INSPECTORS REPORT

WASTE LICENCE REGISTER NUMBER 138-1

APPLICANT: Castle Contracts (Ireland) Ltd.

FACILITY: 'Russborough Landfill', Russborough, Blessington, Co. Wicklow

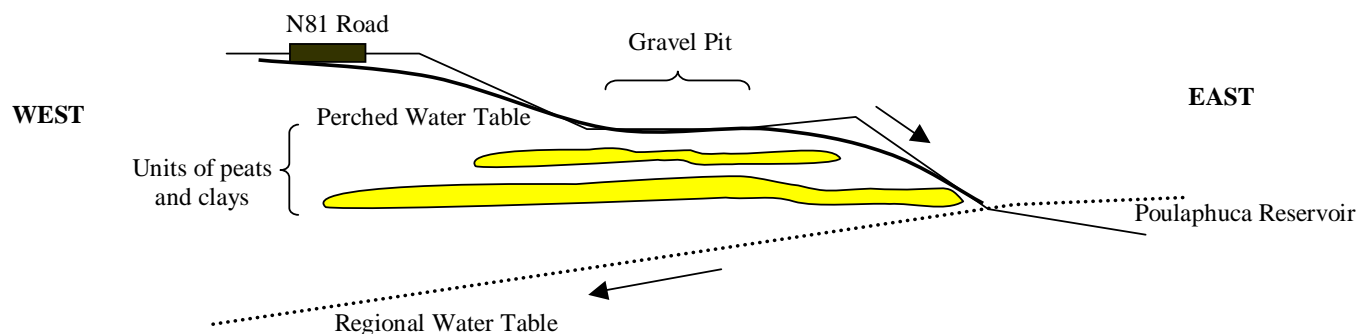
The applicant has provided a detailed compilation report on the hydrogeology of the pit and the interaction of the adjacent Poulaphuca reservoir (200m east), with a review of a topographical survey carried out in March 1997. The reservoir was formed by the construction of a dam at Poulaphuca in the 1940s which raised water levels in the River Liffey causing the river to burst its banks and form a large lake. As a result there is a certain amount of leakage into the surrounding sand/gravel deposits. Topographically the pit floor and pit pond (189.6mOD) lie 3.3m higher than the water level in the Poulaphuca reservoir (186.3mOD). Hydrogeologically the pit floor is underlain by two gravel aquifers – a local perched groundwater body resting on the clayey peats, and a deeper regional groundwater body to which the Poulaphuca reservoir slowly leaks. The perched watertable is actually coincident with the seasonal pond at the pit floor (189.6mOD), and the deeper watertable lies at an elevation of c.177mOD. The above may be visualised in the schematic diagram below:

The applicant describes that all arising leachate or drainage from the pit/proposed landfill will runoff to the deeper groundwater table and hence flow away from the reservoir, westwards. However, I disagree with this. No assessment has been provided on the aspects of the shallow perched groundwater body which flows east to the reservoir, and would drain part or all of the gravel pit. This issue is further developed in Section 9 of this report.
